Critique of “Chernobyl on the Hudson?”

Executive Summary

RBR Consultants, Inc.

FIGURE A-1 Lyman's Cancer Death Estimates

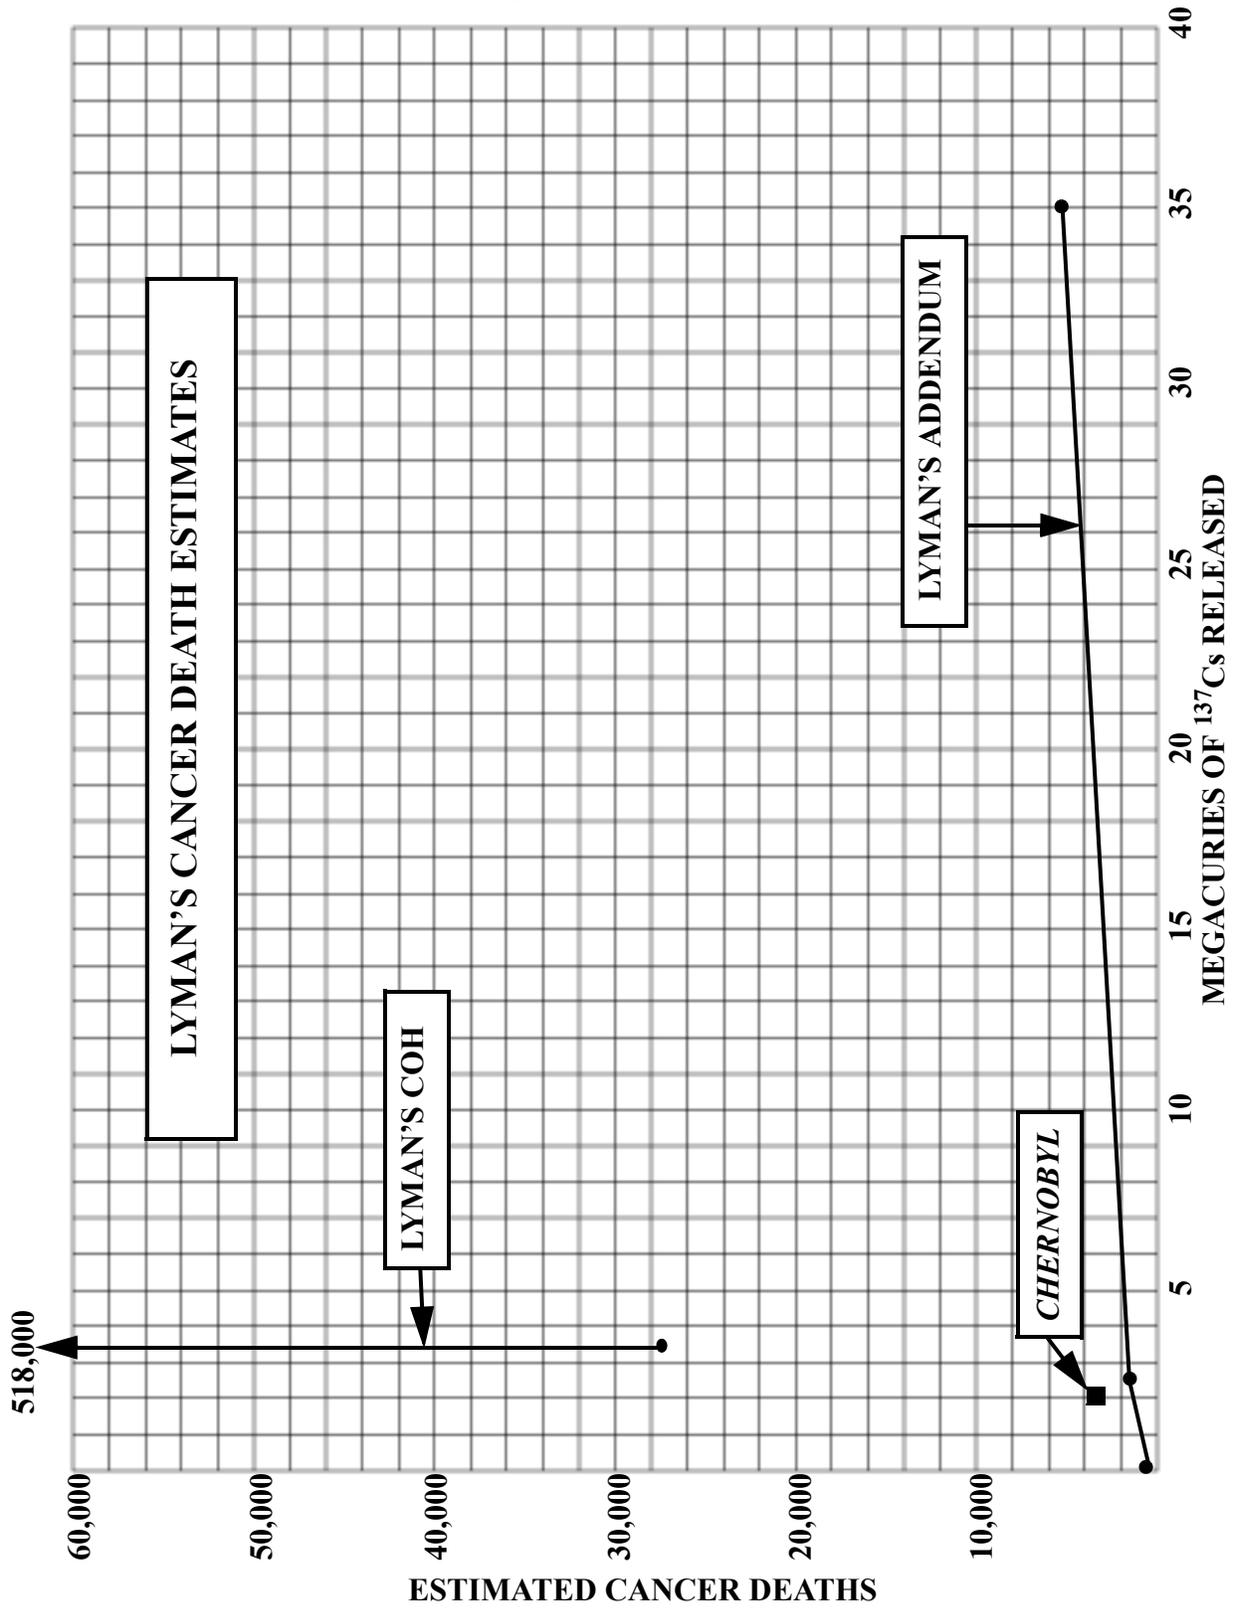
FIGURE A-1 utilizes the Indian Point data from TABLE A-1 to plot cancer deaths versus the size of the ^{137}Cs release, in megacuries. Based on TABLE A-1, a 35 MCi release of cesium from Indian Point would result in 5600 cancer deaths and a release of 3.5 MCi would result in 1500 cancer deaths. It was possible to add a third point: the number of cancer deaths would be zero if the number of released megacuries of ^{137}Cs were also zero. This third point is similar to the Three Mile Island accident which, effectively, had a zero cesium release.

the peak value. However, unlike the Chernobyl results that correlate well with FIGURE A-1, the COH calculated cancer deaths are literally off the charts.

FIGURE A-2 Lyman's Indian Point Offsite Cost Estimates, Billions of Dollars

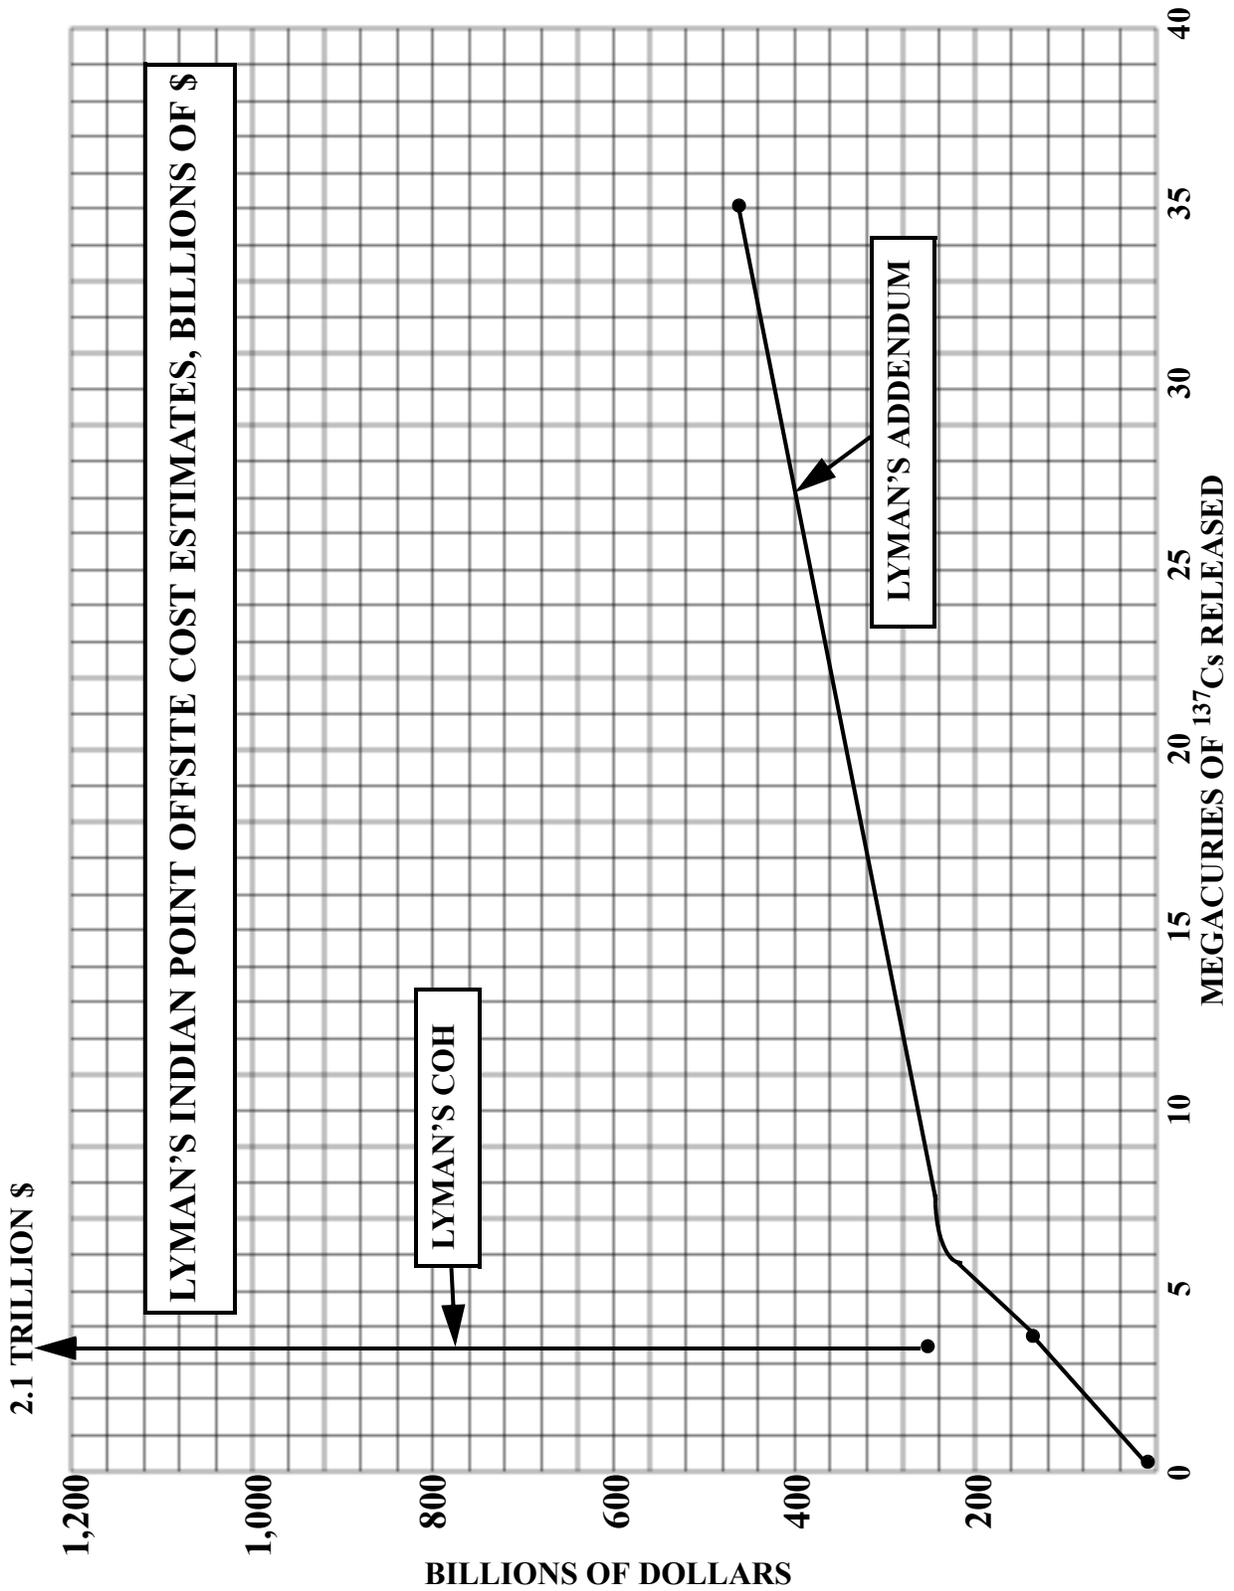
The cost data from TABLE A-1 for Indian Point was used to generate total costs versus cesium release. At an assumed release of 35 MCi, TABLE A-1 lists offsite economic losses at 461 billion dollars. At an assumed release of 3.5 MCi TABLE A-1 lists economic losses at 145 billion. As in the case of FIGURE A-1 a third point was generated where a zero release of radioactive material would result in a zero offsite cost due to actual radiation issues. These three points are plotted in FIGURE A-2.

Once again, the COH's TABLE 9 cost figure from 371 billion dollars to 2.1 trillion dollars is totally inconsistent with Lyman's own TABLE A-1. If COH's unrealistic source term were replaced by the more accurate RBR LOC source term and if the plume were buoyant, then around 20 billion dollars in losses might occur for a successful terrorist event with a large aircraft. If the larger RBR SBO is used and a buoyant plume is assumed, then economic losses might be in the neighborhood of 40 billion dollars. More realistic estimates of offsite losses, which take into account wind shifts, should result in lower cost estimates for all of these scenarios.

FIGURE A-3 Zion Source Term

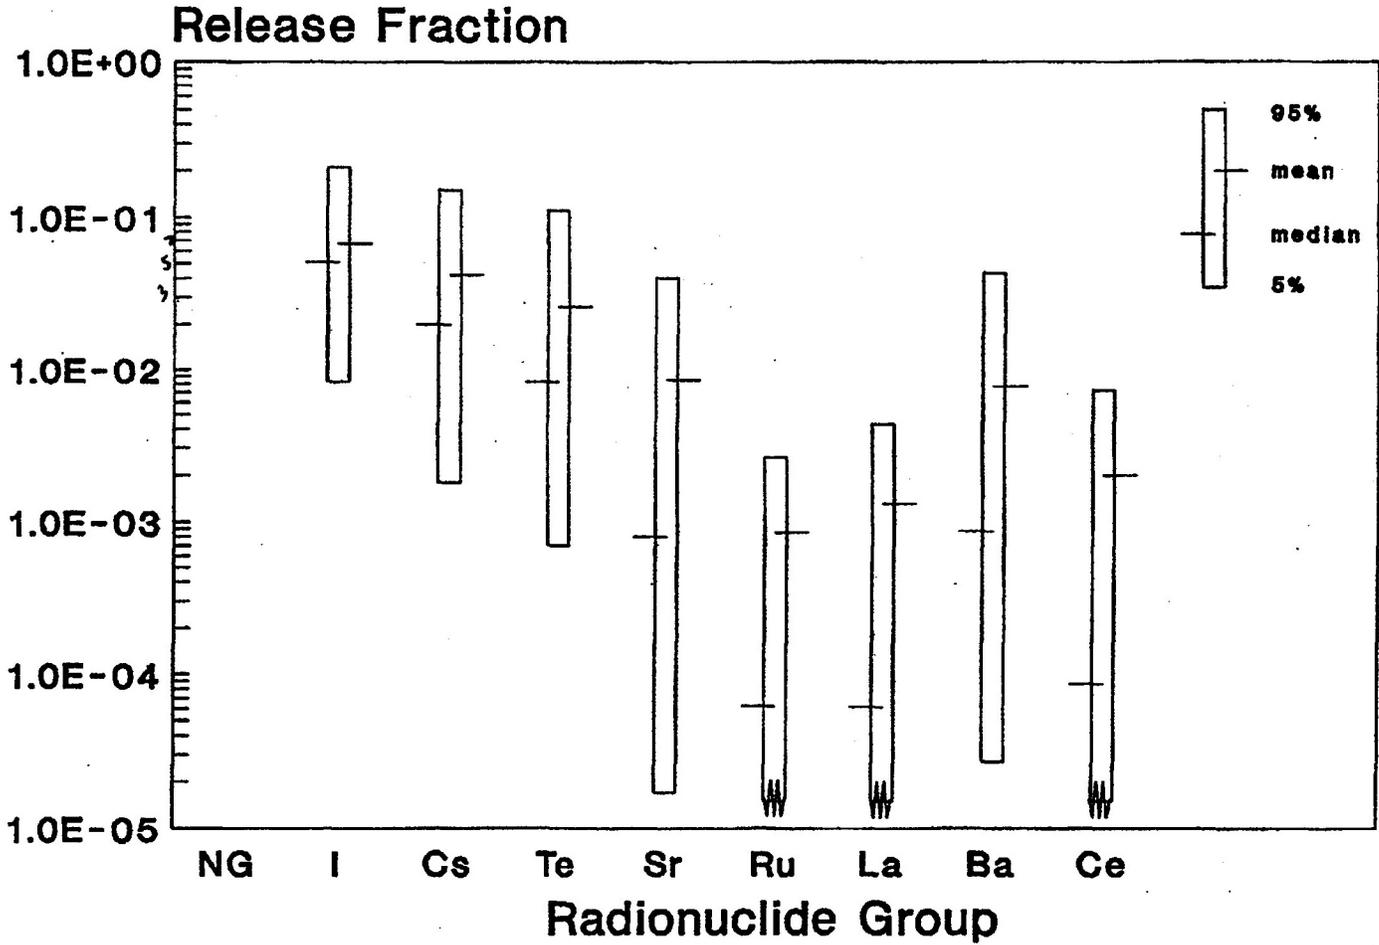
Lyman's terrorist scenario is based on the containment source term for large break LOCAs as described in NUREG-1465. Lyman then postulates that the radioactive material remains within the containment for 1.8 hours and then a pressure spike occurs in the containment due to the failure of the bottom of the reactor vessel. The area in the containment, assumed to be weakened by the airplane crash, then blows open and plume number one is rapidly released to the environment over a period of 0.06 hours. This is followed by plume number two which releases additional radioactive material into the environment over a period of two hours. Fellow intervener Dr. Gordon Thompson (reference [28]) offers a different perspective on source terms "The IP2 and IP3 reactors have large, dry containments. Containments of this type have some capacity to withstand the destructive phenomena that accompany core damage accidents, such as hydrogen explosions or steam explosions. Thus, if containment bypass does not occur, the fraction of radioactive material released from the damaged fuel that reaches the environment might be comparatively small." Thompson's "comparatively small" source term statement for non- bypass events is directly opposite to the very large source term used by Lyman in his COH report. Thompson's statement is consistent with the Zion source term for early releases, as shown in FIGURE A-3.

Section 10.3 reproduces a figure from NUREG-1150's analysis of a source term from Zion, a plant quite similar to Indian Point, for an early release sequence. The Zion plant, also referred to by Lyman, shows much a smaller source term than Lyman used. This figure underscores the observation that Lyman's comparison of MAAP to the STCP is a "red herring" because the STCP analysis does not have a source term nearly as large as what Lyman claims.

FIGURE A-4 Probability of Wind Shifts at Indian Point versus Hours

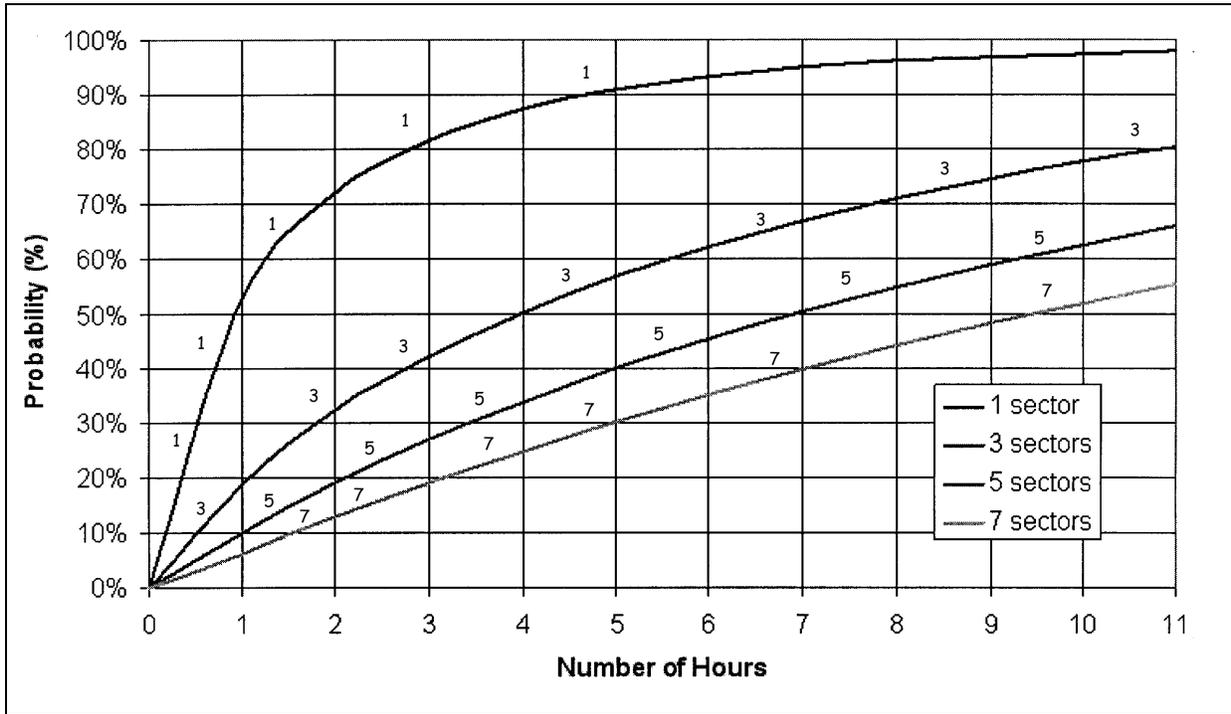
Section 10.4 is just a single figure that plots the probability of wind shifts versus time, using Indian Point meteorological data. These data show that there is an extremely small probability that the centerline of a plume will remain stationary for the duration of a release from a damaged plant. On the basis of measured meteorological data, the centerline consequences that he claims is not meaningful because it is so unlikely. This conclusion is further supported by the fact that Lyman's source term is too large. Correcting the source term plus accounting for the very low probability that the centerline of the plume would remain stationary for long periods of time leads to the conclusion that the centerline doses that Lyman has published are not risk significant and perhaps impossible.
